Issue	**1**
Factory ID	**920016**
Date of Issue	**22-Apr-2026**

Agility Textile (Pvt.) Ltd.

Fire Safety Inspection Report

Pakistan Accord Initial Safety Inspection Report

Figure 1.4. Egress layout plan of Main building

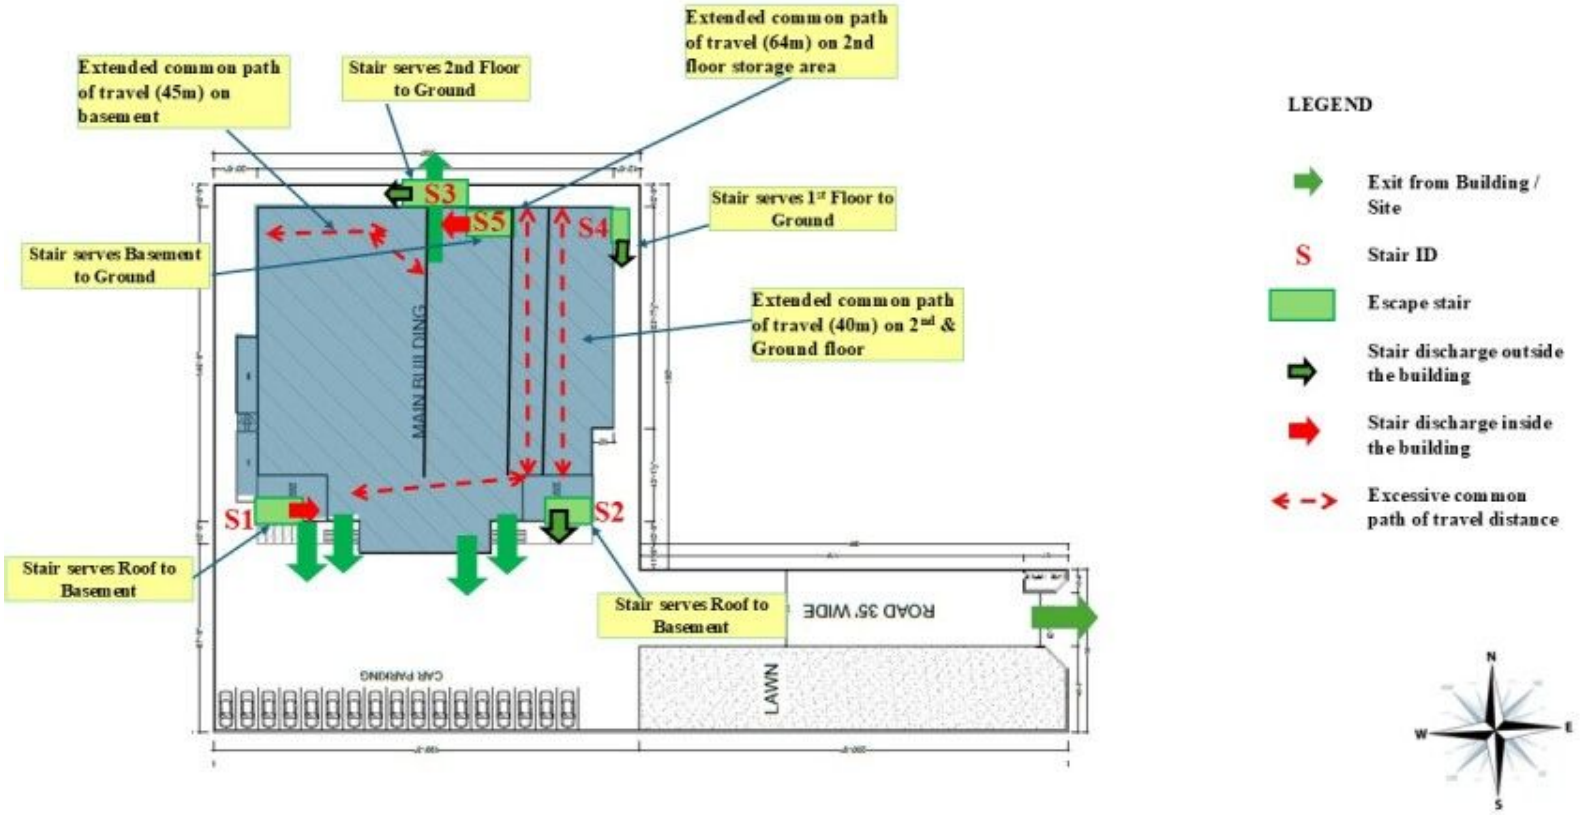
There is sufficient exit capacity in building & travel distance Common path exceed permitted limits. e.g. Extended Common path of travel in Main building in different locations like 45m on basement ,40m on ground floor & second floor studio office & 64m on storage area 2nd floor. Single exit issue observed at the mess area on the second floor.
